Johnson Creek Floodplain Zoning Code Maintenance

Revising the Johnson Creek Basin Plan District
to Incorporate the Most Current FEMA Flood Maps

Exhibit A: Planning Commission Report and Recommendations to the City Council

Adopted by the Portland City Council
July 9, 2003, Ordinance No. 177689

Proposed Changes

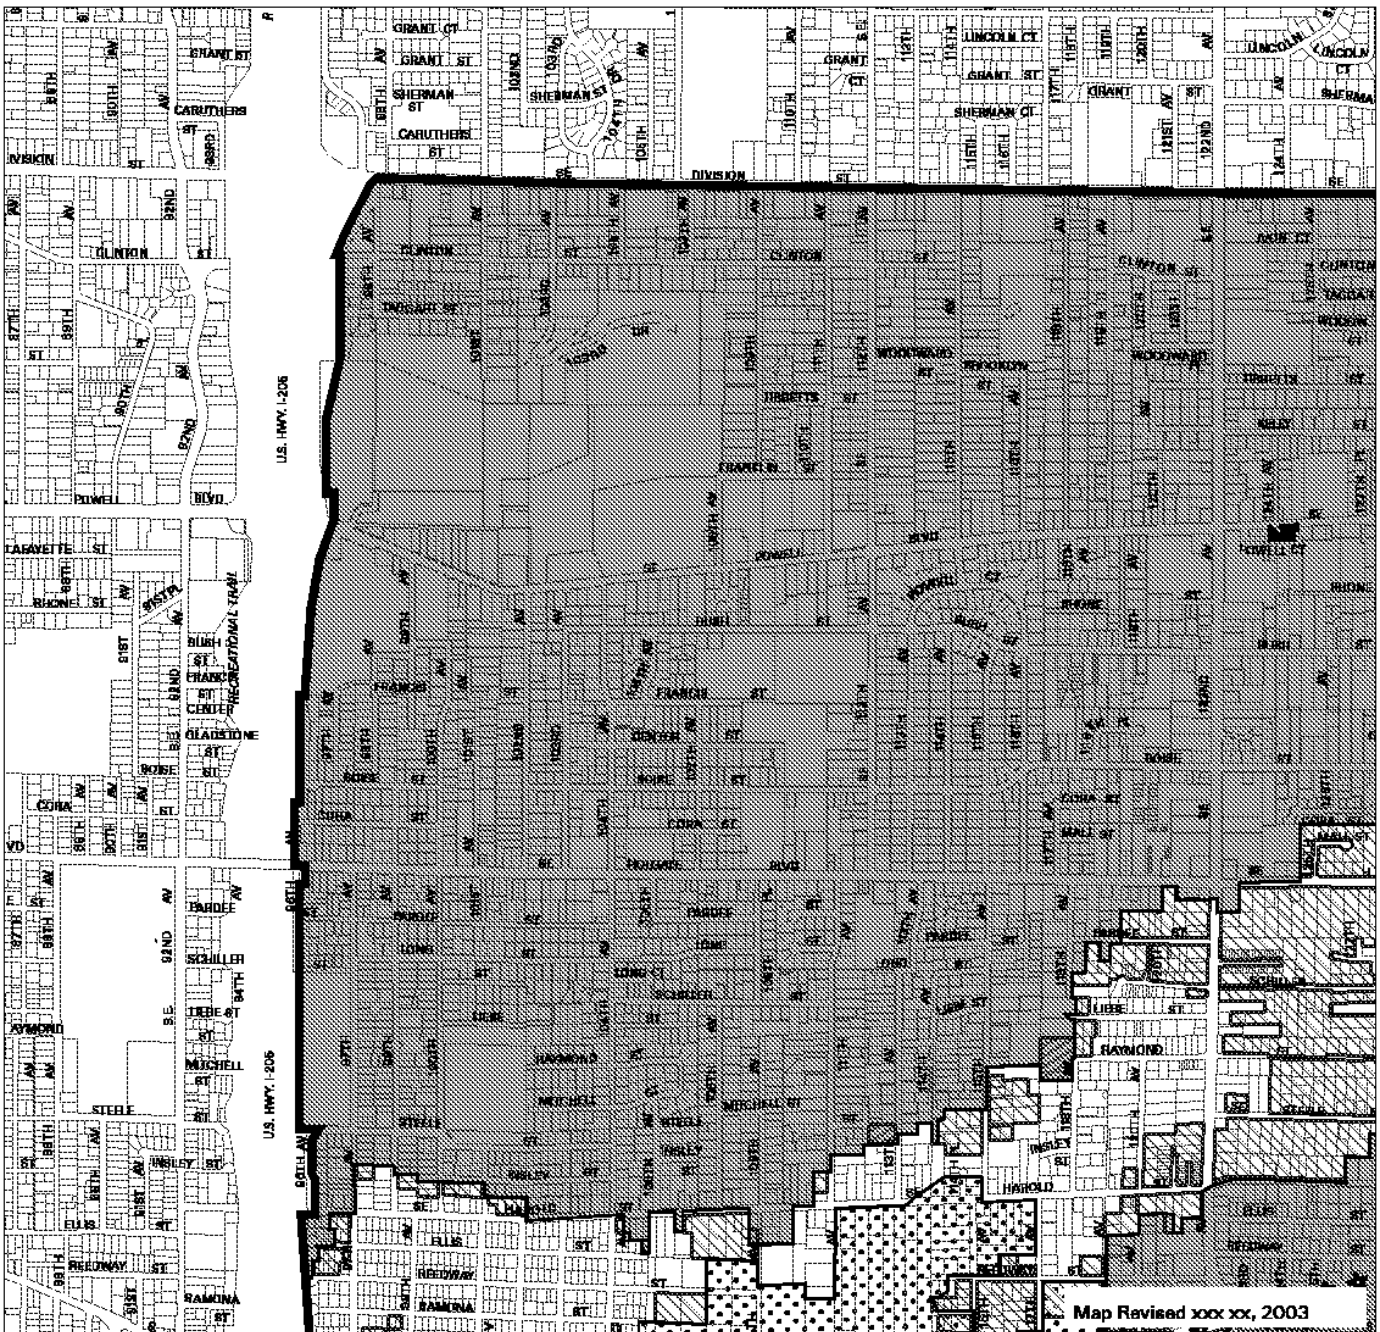
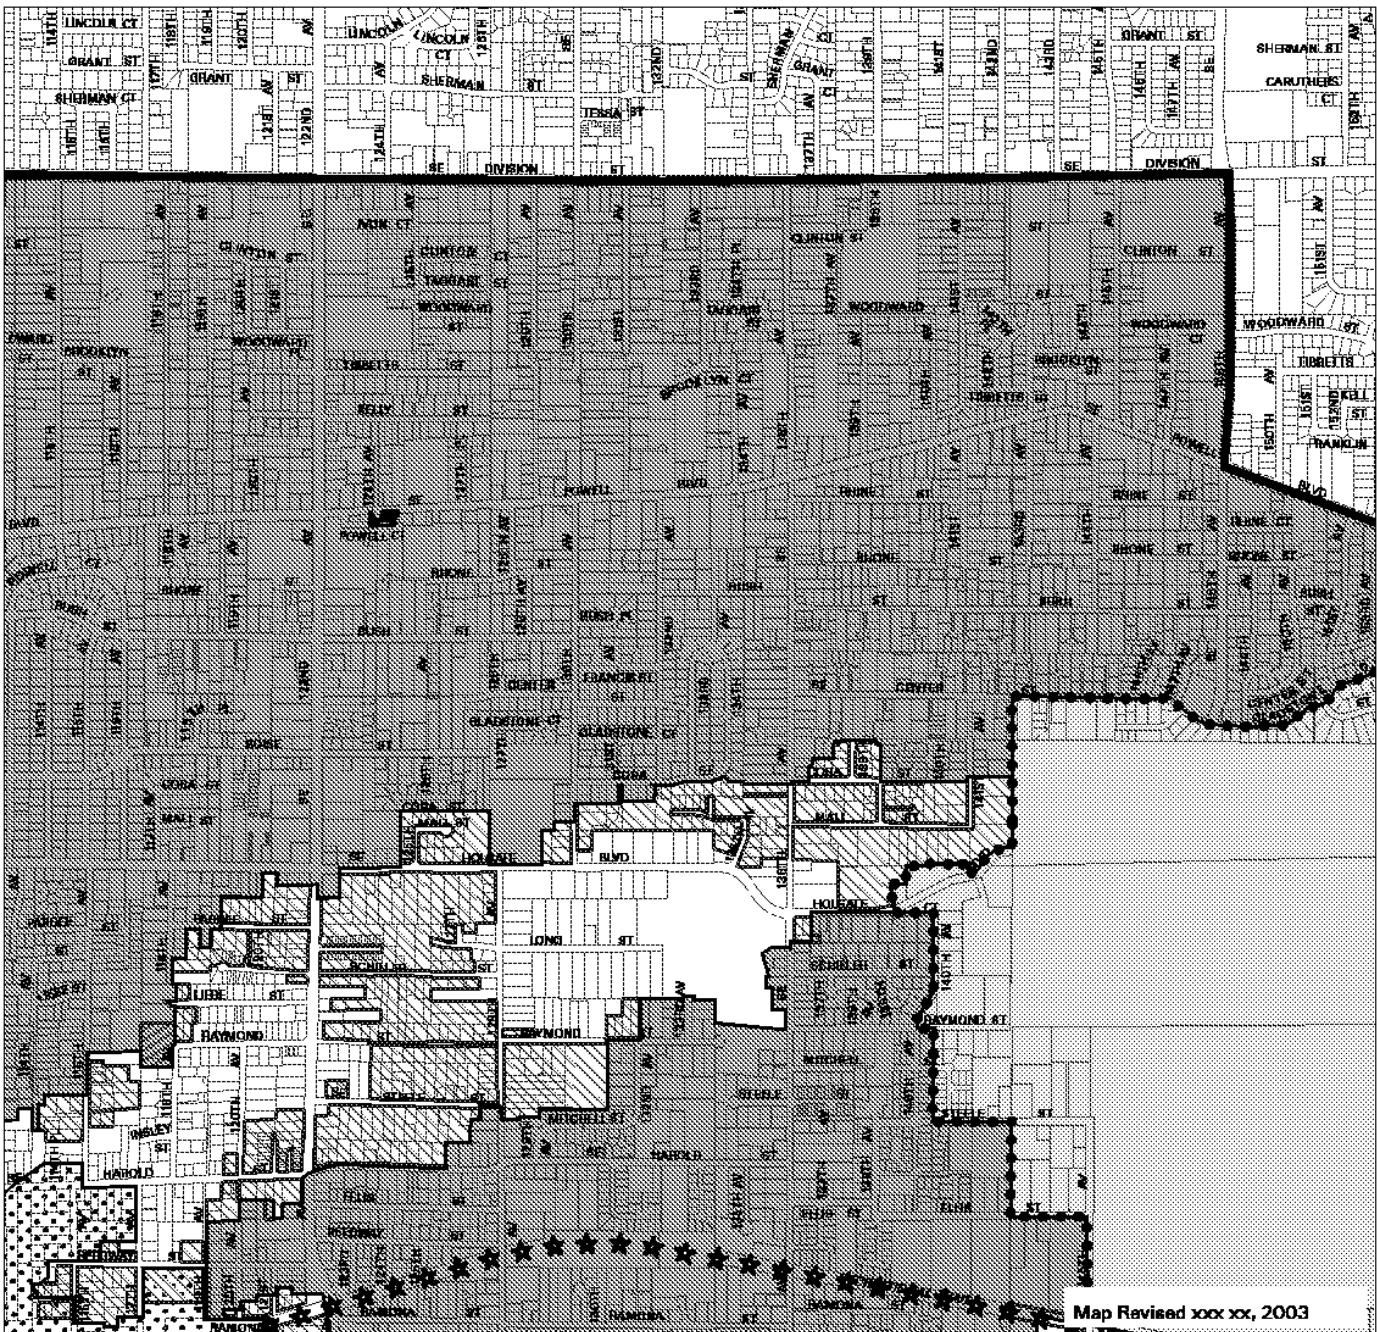
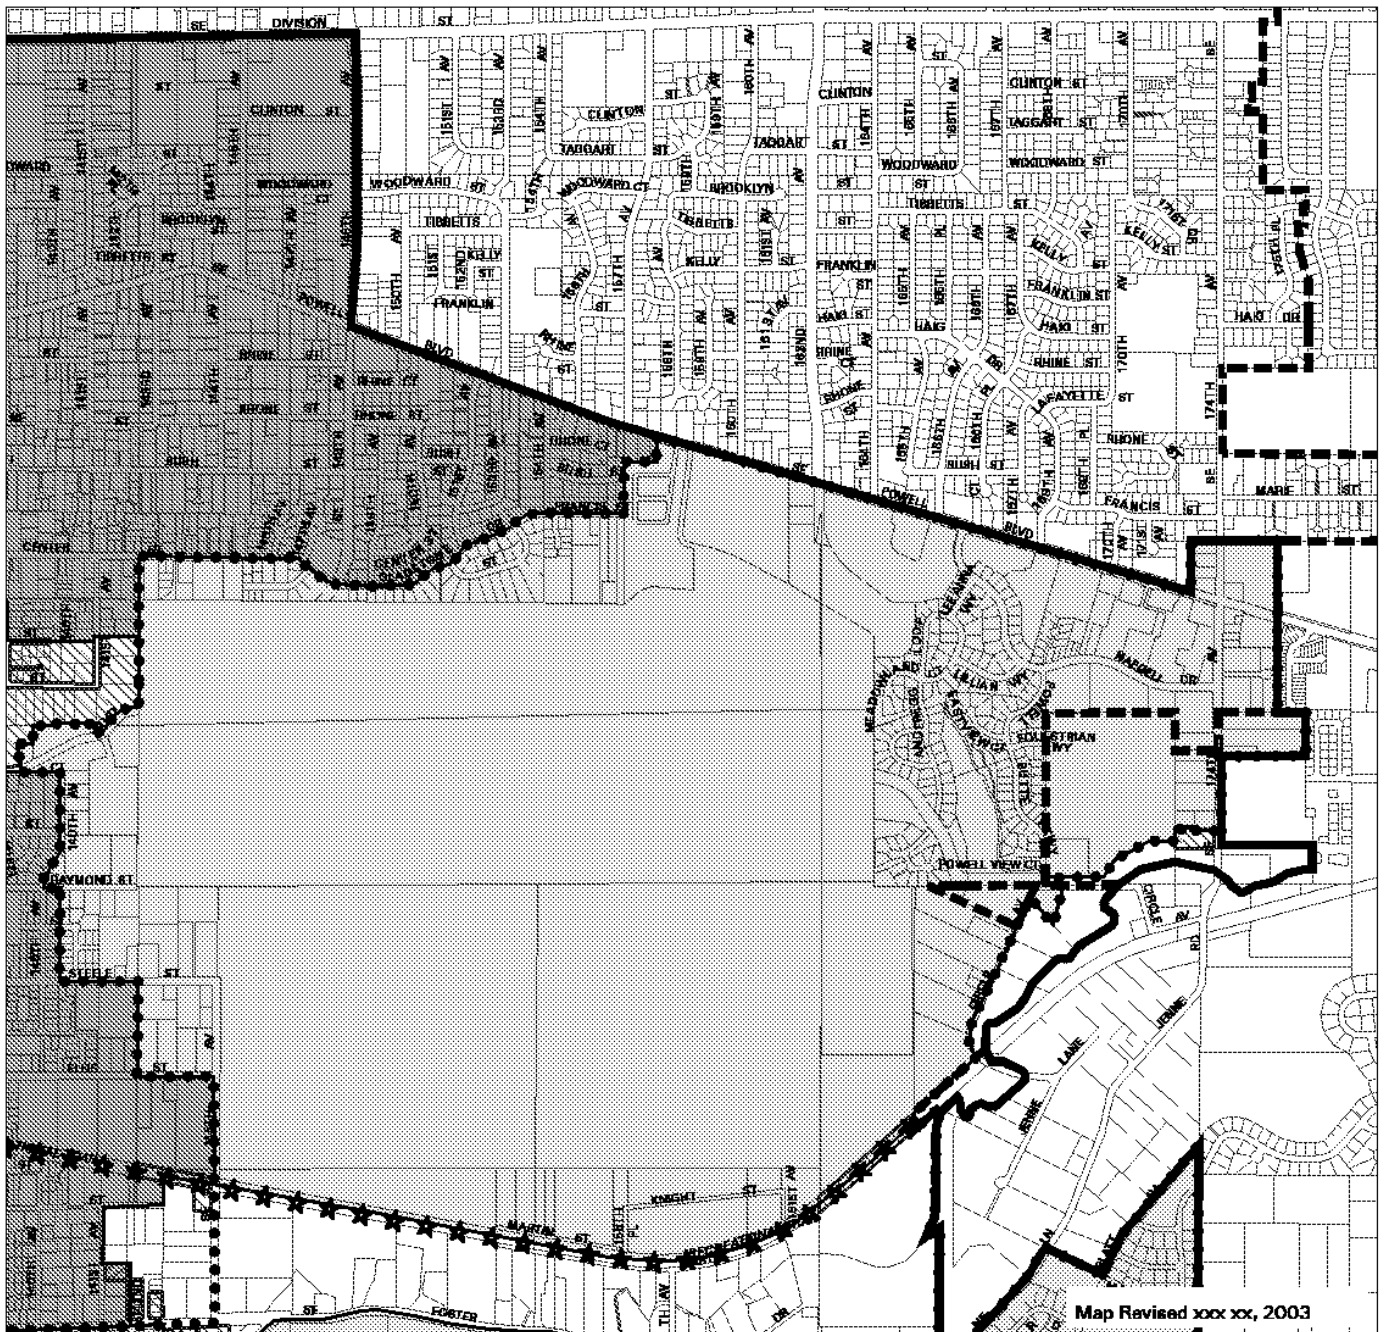
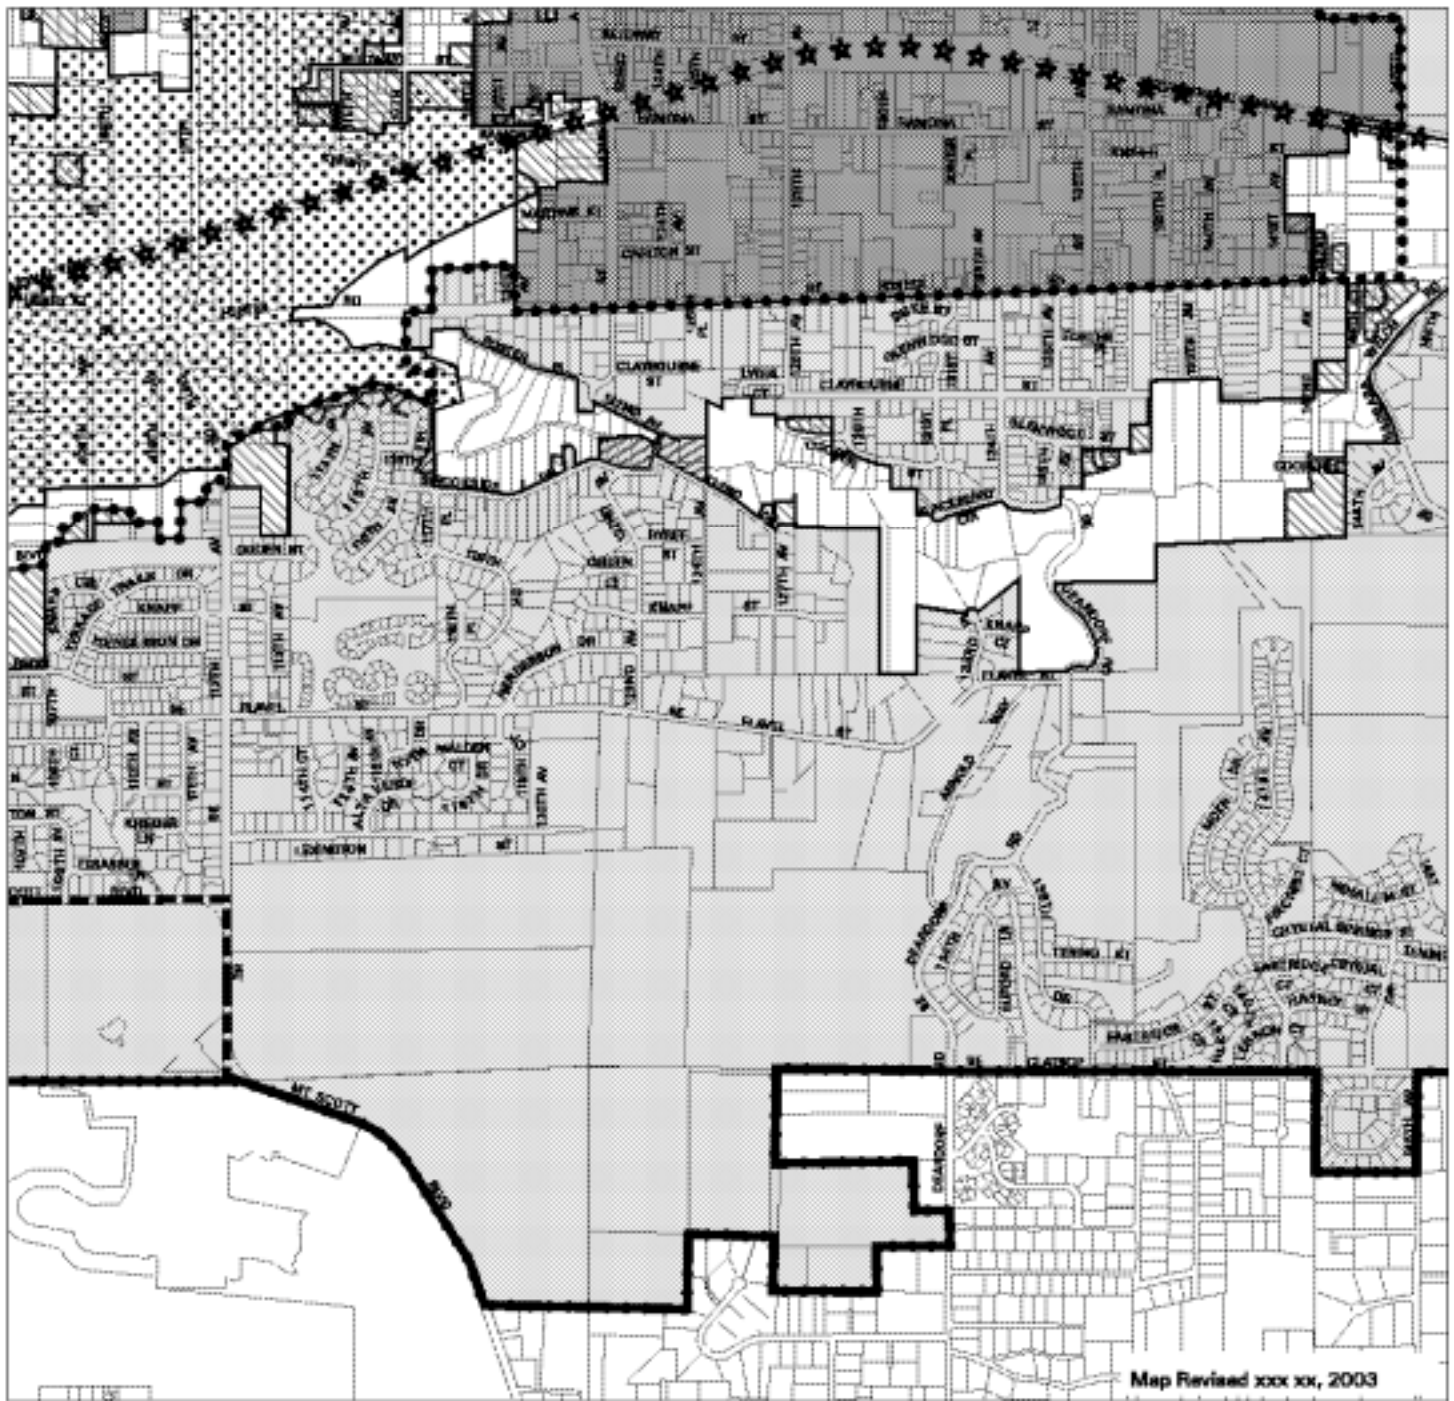
This second set of maps includes additional information to help readers understand the proposals in this report. This information will not be included on the official *Zoning Code* maps. These maps show all the sites that have been removed from, or added to, the floodplain as a result of FEMA's update. The maps also show the Kelly Butte and Johnson Creek Flood Plain subdistricts with a note in the legends that explains that the Johnson Creek Flood Plain subdistrict will no longer be identified on the zoning maps and the Kelly Butte subdistrict will be eliminated.
